**Date:** March 24, 2026  
**To:** City of Seattle Landmarks Preservation Board  
**CC:** Erin Doherty, Landmarks Preservation Program Staff  
**From:** David Graves, AICP, Strategic Advisor  
**Subject:** Gas Works Park Cracking Towers – Pedestrian Appurtenance Removal Certificate of Approval Application

### **Certificate of Approval Request**

**GAS WORKS PARK**

**EMERGENCY DEMOLITION**

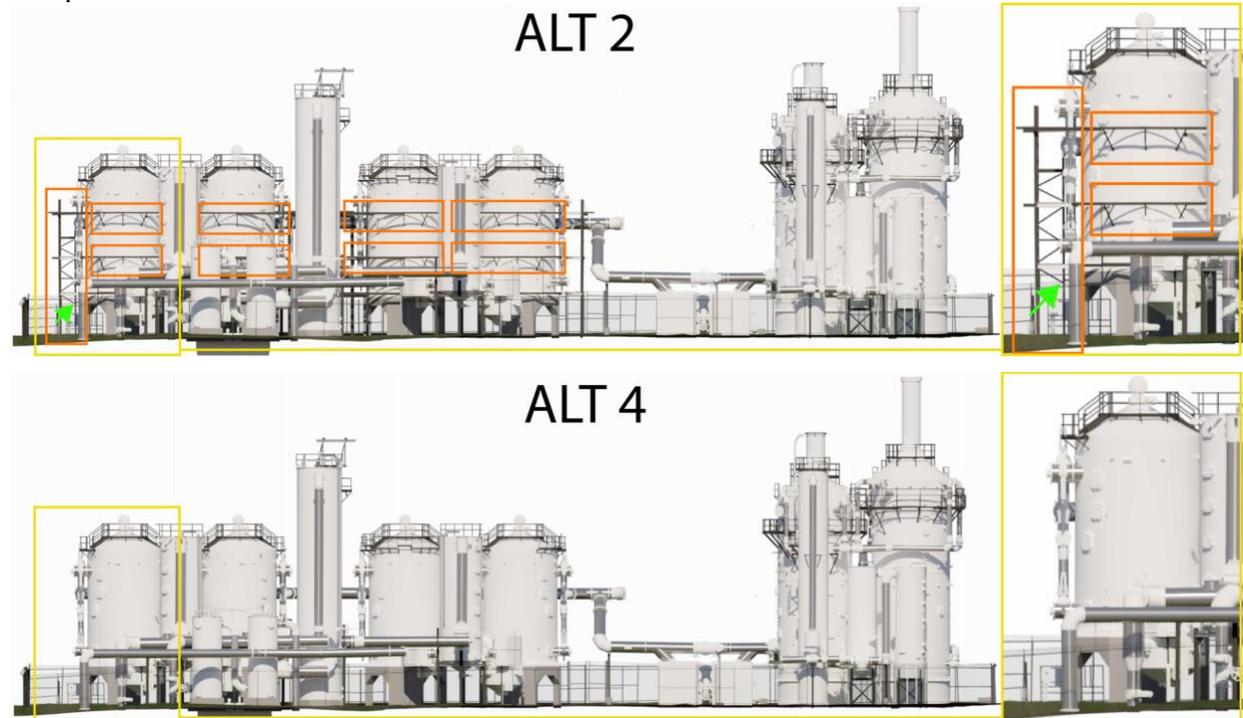
In our review of the proposals, we noted that in the scope of work, both proposals called for "Selective removal of piping, catwalks, ladders and support systems from tower structures located within Gas Works Park." The proposal titled "Gas Works Park Surgical Demo\_ALT 4" (ALT 4) had more components (piping, catwalks, ladders and support systems) selected for removal than "Gas Works Surgical Demo\_ALT 2" (ALT 2); see Figure 1, Figure 2 and Figure 3. In the elevation

depictions of the Gas Works Park Towers components from ALT 2, there are supporting components for several catwalks that are not selected for removal.

The supporting components for several of the catwalks that are not selected for removal in ALT 2 are approximately 11 to 12 feet above the ground; see Figure 2 and Figure 3. Additionally, there was a lower component not selected for removal in ALT 2 that was less than 11 feet in height; see Figure 1 and Figure 2.

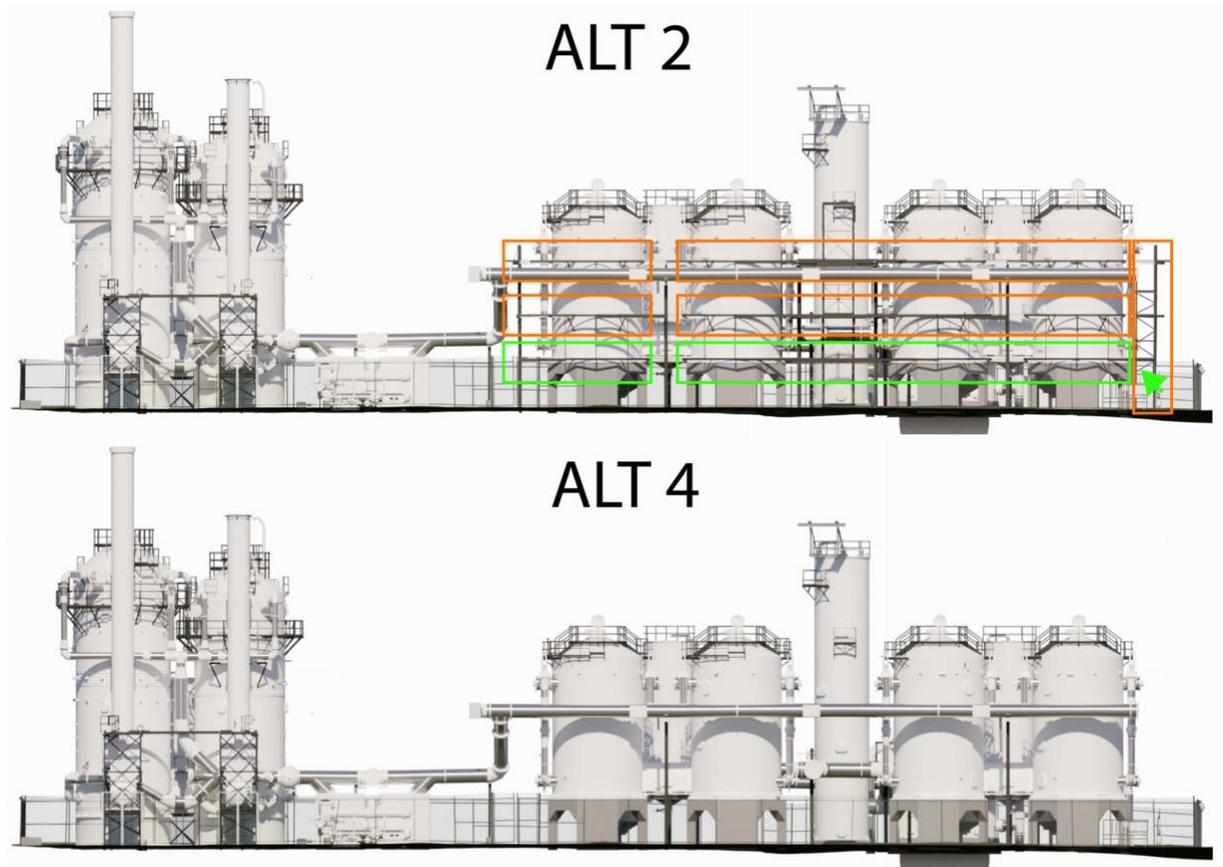
There are additional components selected for removal in ALT 4 compared to ALT 2 as depicted in the north elevation images; see Figure 3.

ALT 4 north towers detail 2/D1.06

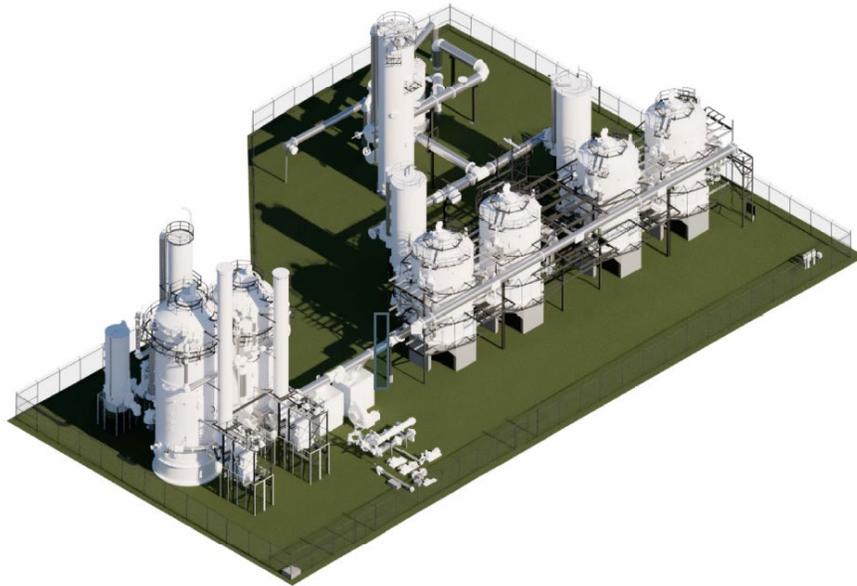
ALT4 clearly is better for meeting the City's interest in removing opportunity to trespassers. This actually seems to be a good arrangement as it removes most of the lower climbable areas of the less-visible north towers.

We understand that ALT2 was prepared in response to Landmark's desire to maintain more of the ladder and catwalk appearance throughout the facility. Unfortunately, ALT2 remains highly attractive for potential trespassers. Especially on the north towers, we recommend that the lower level of catwalk framing also be removed if this alternate is selected. As currently shown, we are concerned that trespassers will view these lower-level catwalk frames as climbable. We recommend full removal of the lower framing. Based on experience I expect the columns without the first level of catwalk framing to be stable, but suggest that this be analyzed by a structural engineer during any removal activity.

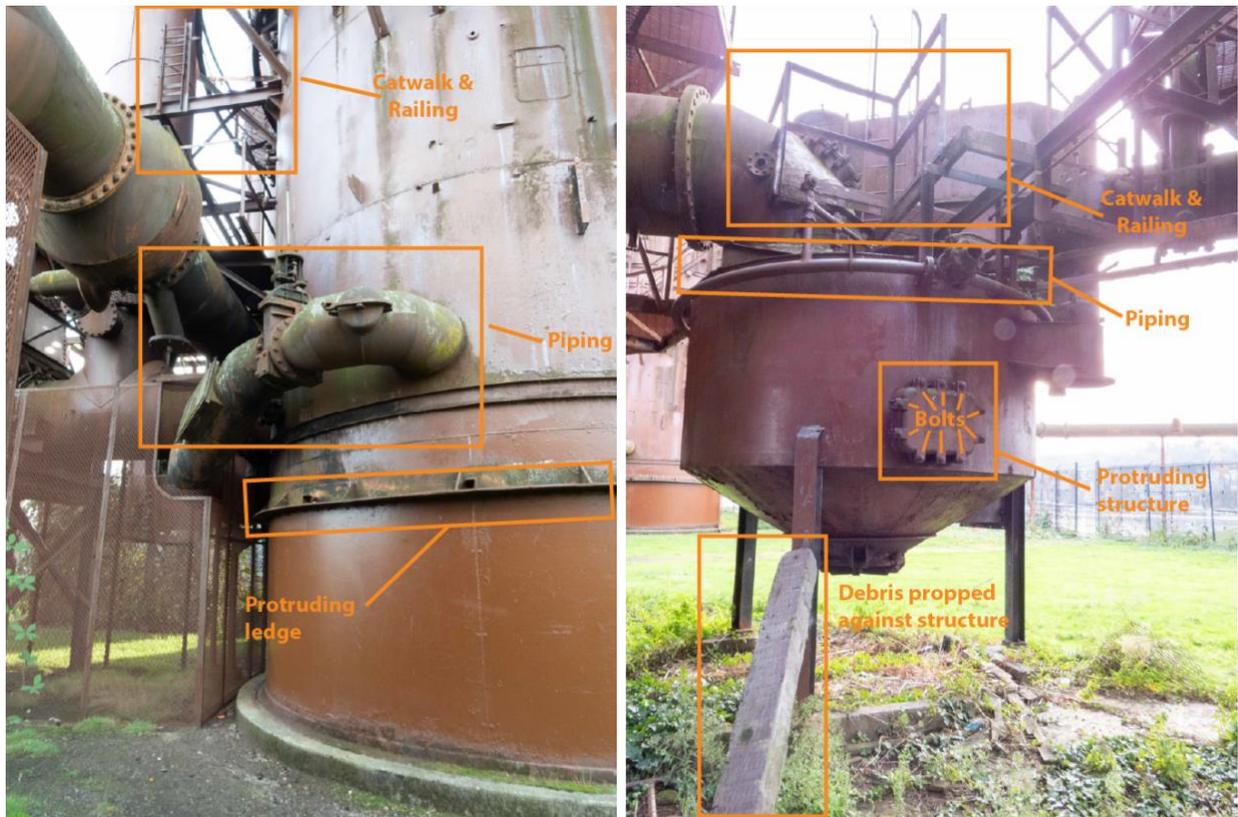
On the south towers there was a protruding ledge that was approximately 6 feet above a concrete slab that protruded approximately 8 inches from the vertical tower wall; see Figure 11, left. Above the protruding ledge was piping that was less than 11 feet in height from the protruding ledge below and further in height was a catwalk and railing. In another area, there was a protruding structure that was approximately 7 to 8 feet above the ground and protruded approximately 7 inches from the vertical wall; see Figure 11, right. This structure had bolts that provided additional areas for finger holds. Above the lower protruding structures there was piping and a catwalk and railing within 11 feet in height.

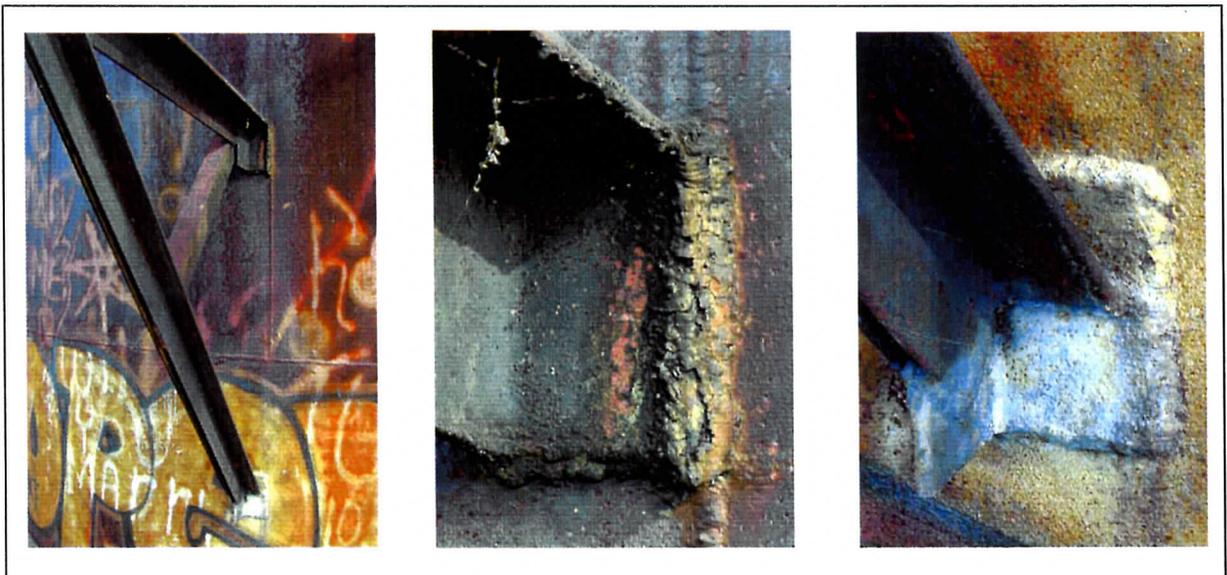
1. Supporting Level 2 catwalk, shell depressions at the catwalk knee braces along the south side.

2. Typical stair support brace system.

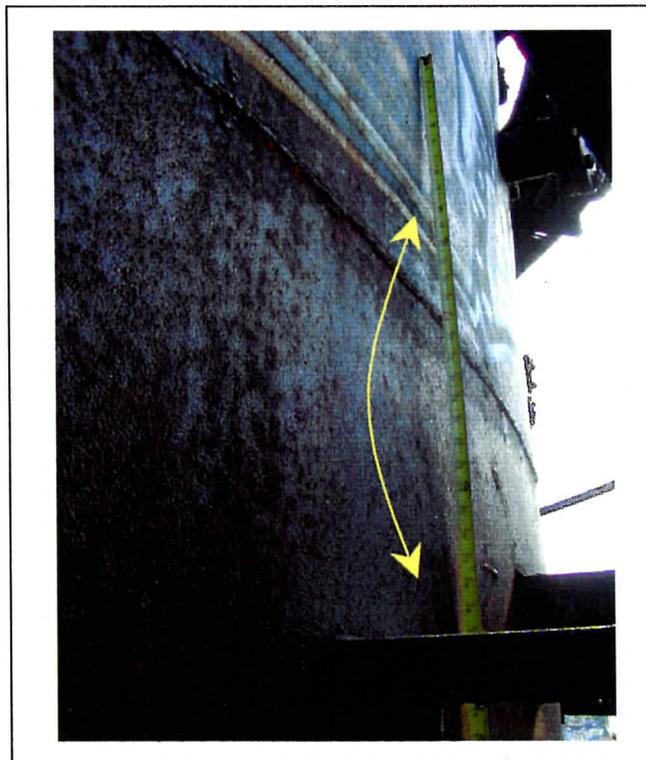
3. South stairway from catwalk levels 2 to 3 has missing stair steps. Bolts have failed at various treads due to corrosion-separating some stringer channels from grating steps. Catwalk grating has numerous panels missing and is heavily corroded. None of the stair or catwalk grates appear to be in a safe or usable condition.

4. Deformations and buckles in shell walls at the south elevation of catwalk Level 1. Depressions and buckles are 1" nominally out of plane.

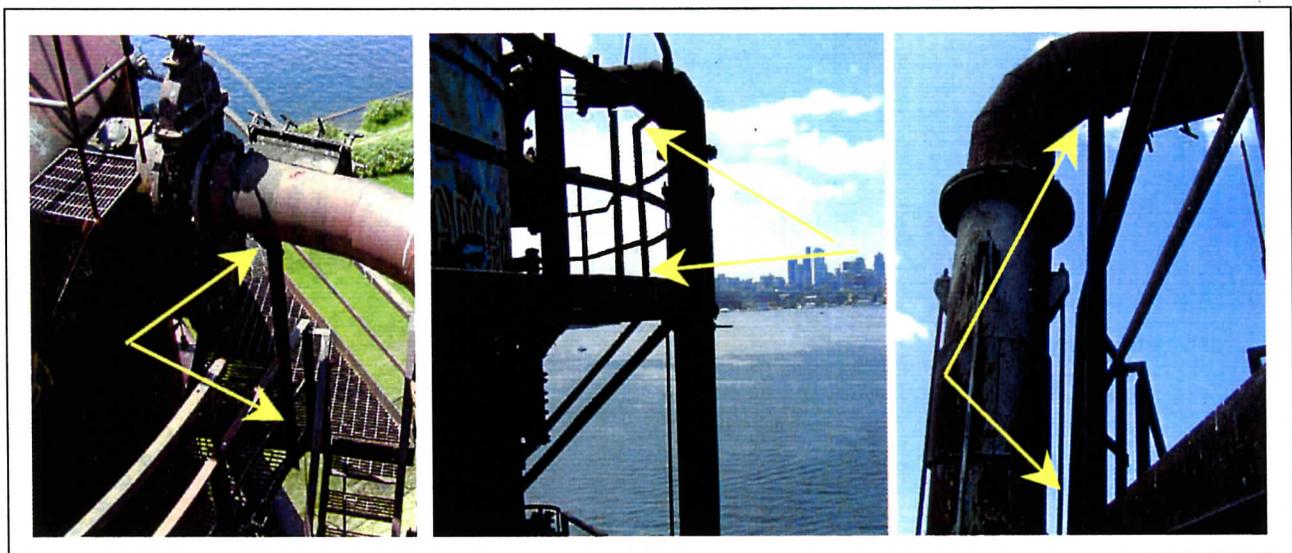
5. A repair weld was made to a tear/crack in the shell at catwalk Level 2. The shell also has a depression at this nozzle location.

6. Welds of catwalk support systems appear to be in fair condition with no apparent in service failures.
